LiDAR Quality Assessment Report

VT-AddisonLiDAR-Lot1of1_2012

Addison, VT LiDAR

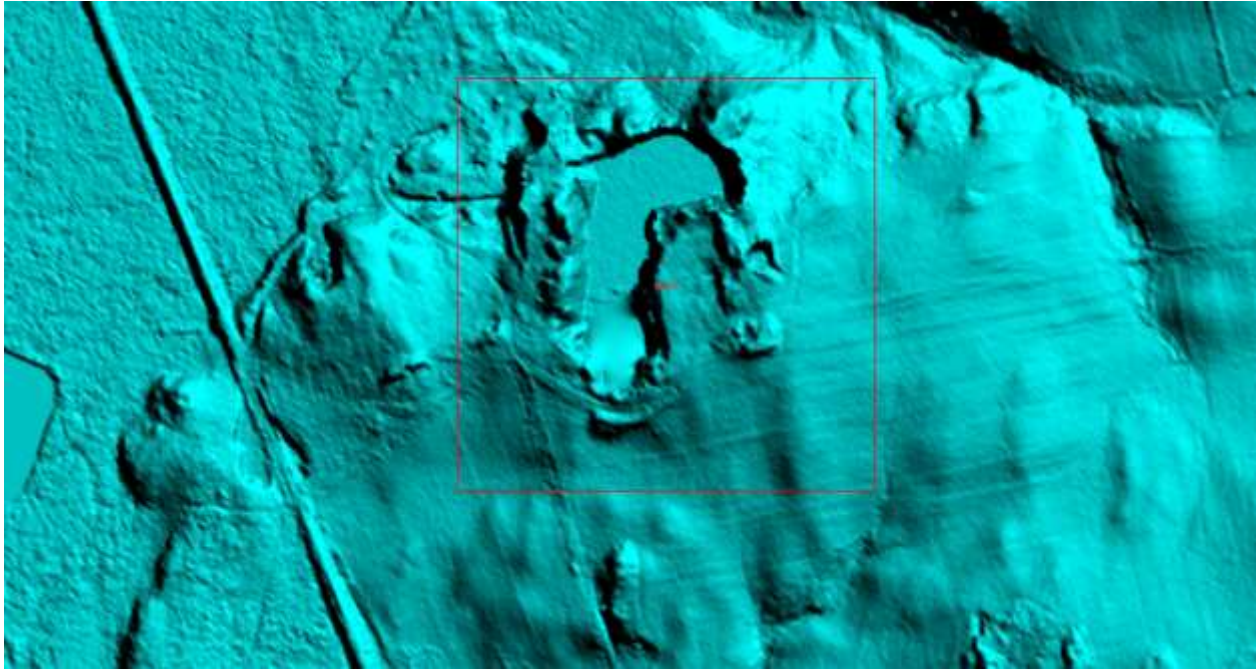
water body > 2 acres needs hydro flattened @
43° 50' 52.6646" N, 73° 08' 28.9909" W

CORRECTED BY VENDOR***
